CONNECTION ASSESSMENT & APPROVAL PROCESS

*Project: Replacement of 230kV Breakers
L23T5 & L23T6 at Lakeview SS*

CAA ID No. 2002-EX030

HYDRO ONE NETWORKS Inc. LAKEVIEW SS - Replace 230kV breakers L23T5 & L23T6

DIAGRAM 1

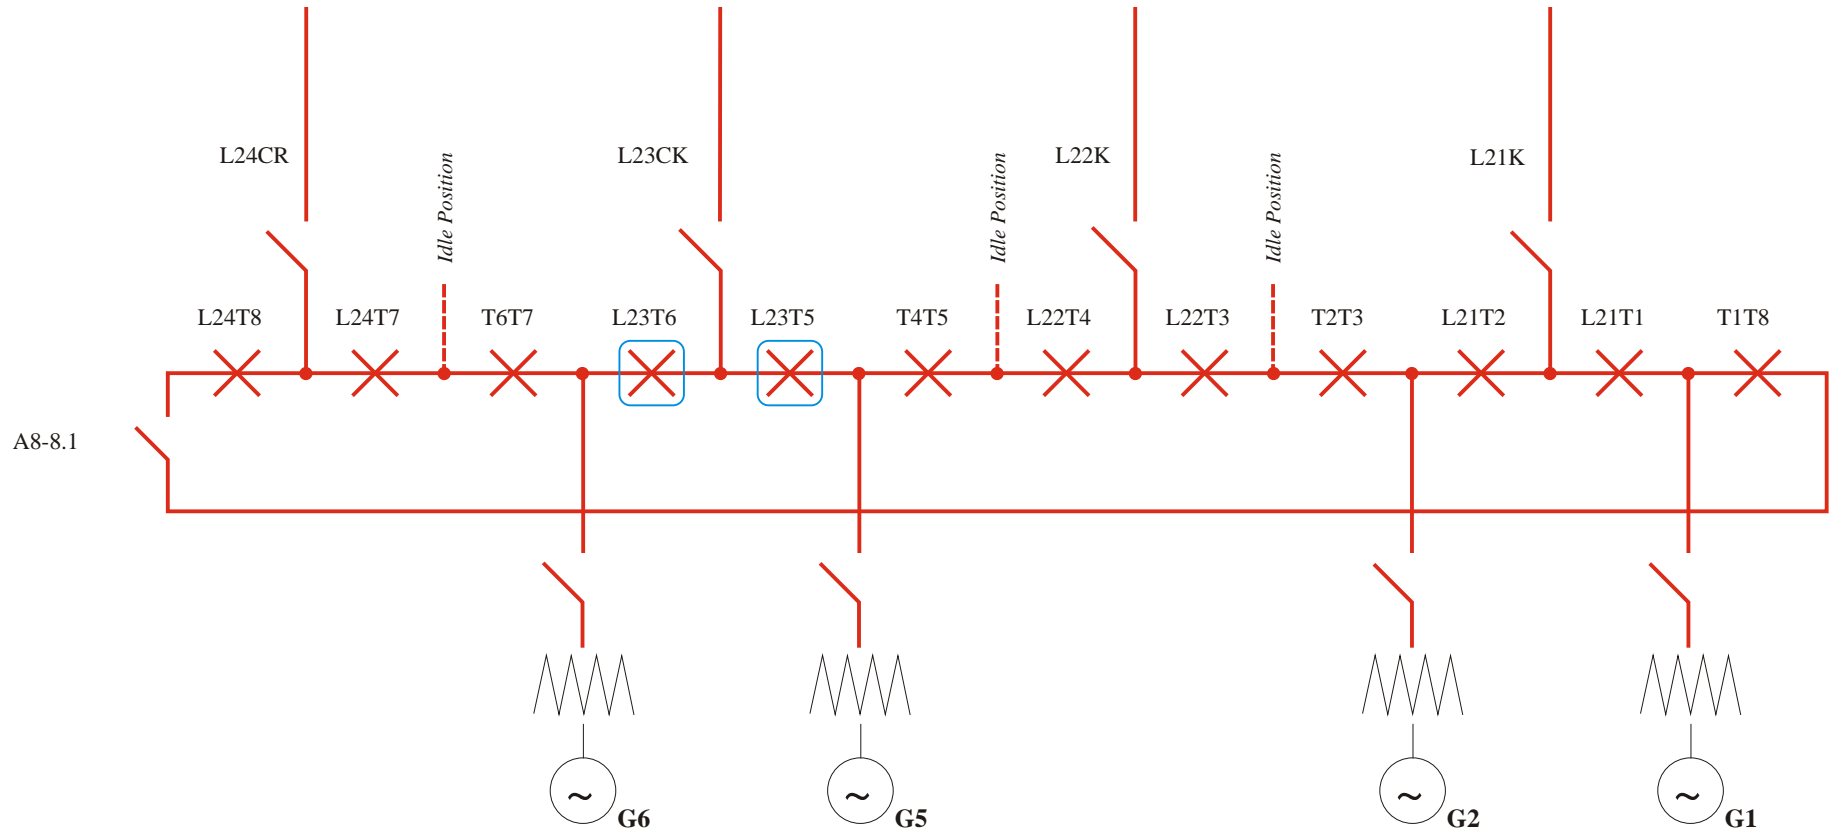
The physical location of the two breakers that are to be replaced at Lakeview SS is shown in Diagram 1.

However, as mentioned in the SIA Report for the Sithe Cluster, one breaker of each of the following pairs is effectively redundant (because an idle terminal occupies the position between the two breakers) and it was therefore recommended that the lower-rated breaker of each pair should be removed and the vacated position by-passed with new buswork:

T6T7 & L24T7	<i>Remove breaker L24T7</i>
T1T8 & L24T8	<i>Remove breaker L24T8</i>
T2T3 & L22T3	<i>Remove breaker L22T3</i>

Once breakers L24T7, L24T8 & L22T3 have been removed, only breakers T4T5 & L22T4 would remain with a lower rating.

Replacing these two remaining breakers would then increase the operational rating of Lakeview SS to 63kA, thereby providing greater flexibility in the manner in which the 230kV busbar can be operated and reducing the occasions on which it would need to be operated split.

Since the replacement of breakers L23T5 & L23T6 at Lakeview SS is considered to represent a like-for-like replacement of existing facilities, it will have no adverse impact on the IMO-controlled grid.

It is therefore recommended that a Notification of Approval of the Connection Proposal be issued.
